Rezoning Transportation Analysis

Petition Number: 2017-035

General Location Identifier: 119-064-22, 119-064-23, 119-064-30, 119-063-13

New Bern Transit Station Area Plan

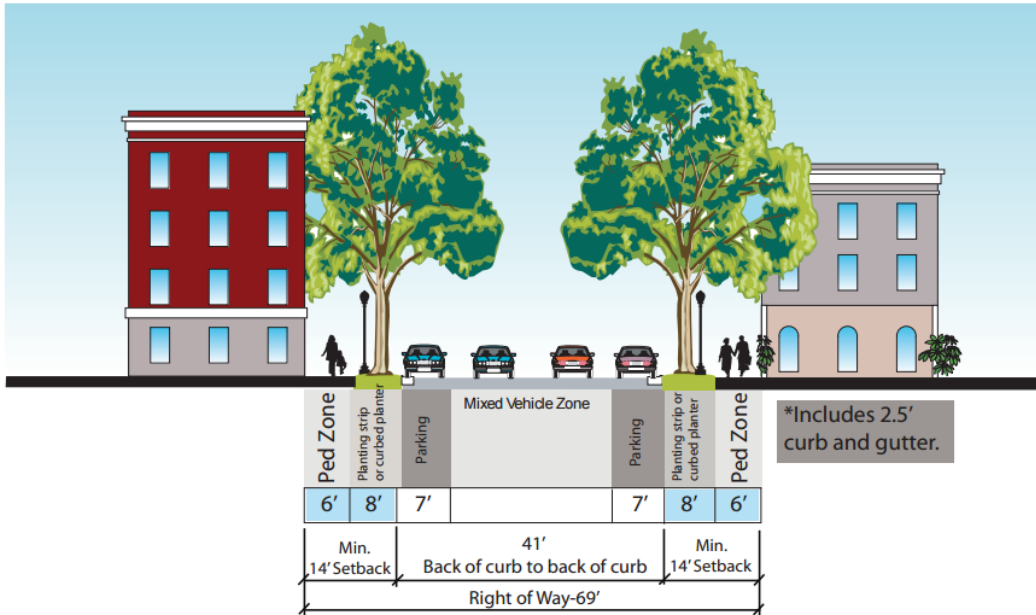
The proposed zoning district has a setback measured from an existing or proposed future curblines. The location of the future curblines per the area plan is 20.50' from existing centerline (see below). However, CDOT is requesting that this curblines take into account a future 7' bike lane. Thus, the future curblines should be placed 27.50' from existing centerline.

1. The petitioner should revise the site plan by relocating the proposed curb 27.50' from the existing centerline of road. This will account for the area plan recommendation in addition to the future bike lane.
2. The petitioner should revise the site plan and the transportation notes to depict and state that the petitioner agrees to allow future cross access to be preserved for such time that redevelopment occurs. This should include depicting stubs and access easements on the site plan.
3. The petitioner should revise the site plan to add a note specifying dedication and fee simple conveyance of all rights of way to the City before the site's first building certificate of occupancy is issued. CDOT requests right of way set at 2' behind back of sidewalk.
